## DEVELOPMENT APPLICATION ASSESSMENT REPORT

<b>Application Number:</b>	DA2021/0853
----------------------------	-------------

<b>Responsible Officer:</b>	Adam Mitchell
<b>Land to be developed (Address):</b>	Lot 116 DP 216019, 222 South Creek Road WHEELER HEIGHTS NSW 2097
<b>Proposed Development:</b>	Alterations and additions to a Dwelling House
<b>Zoning:</b>	Warringah LEP2011 - Land zoned R2 Low Density Residential
<b>Development Permissible:</b>	Yes
<b>Existing Use Rights:</b>	No
<b>Consent Authority:</b>	Northern Beaches Council
<b>Land and Environment Court Action:</b>	No
<b>Owner:</b>	Andrew Benjamin McPhee Hadeer Ehab Wadih McPhee
<b>Applicant:</b>	Nigel White

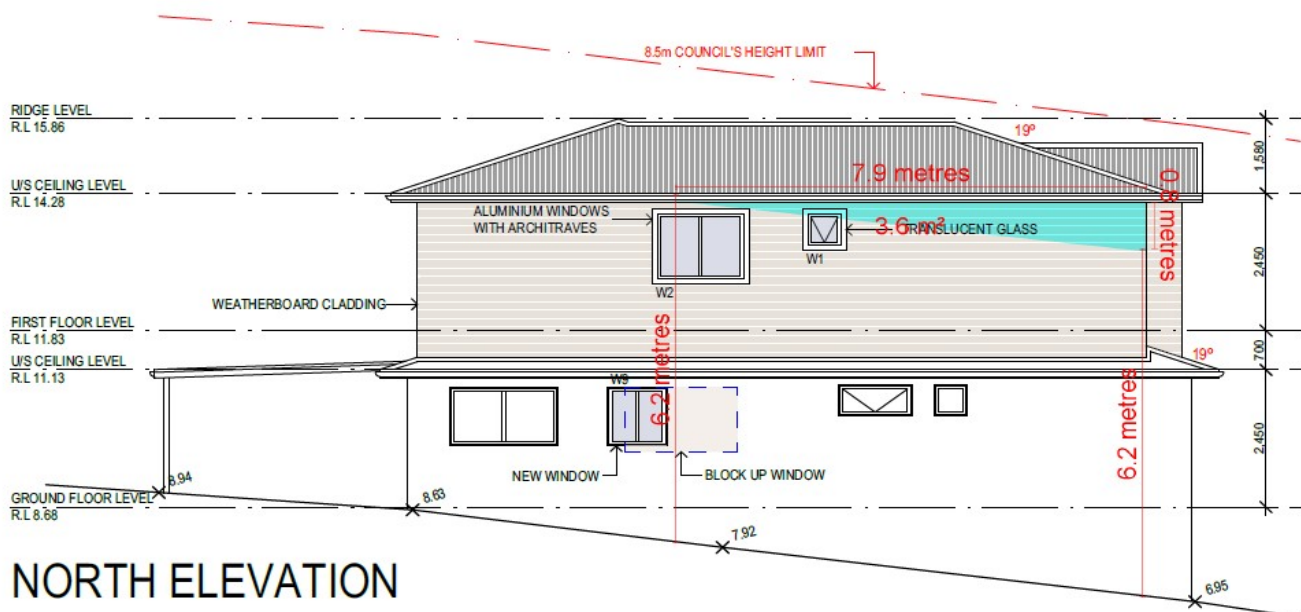
Clause B3 of the Warringah Development Control Plan 2011 prescribes a 4m side boundary envelope. The northern flank elevation of the proposed building encroaches said envelope in the form of a diminishing triangle with a maximum height of 0.8m and a length of 7.9m equating to a variation of 20%.

The extent of non-compliance is highlighted blue on the below diagram:

The proposed development complies with all other built form controls which seek to guide the proportions of a building. The encroaching section of the building highlighted above is not of a proportion which would result in unreasonably bulk or scale. The works are consistent with the height, bulk and proportions of a standard dwelling house and thus, the development is not considered to be visually dominant.

Having regard to the above assessment, it is concluded that the proposed development is consistent with the relevant objectives of WDCP 2011 and the objectives specified in s1.3 of the Environmental Planning and Assessment Act, 1979. Accordingly, this assessment finds that the proposal is supported, in this particular circumstance.
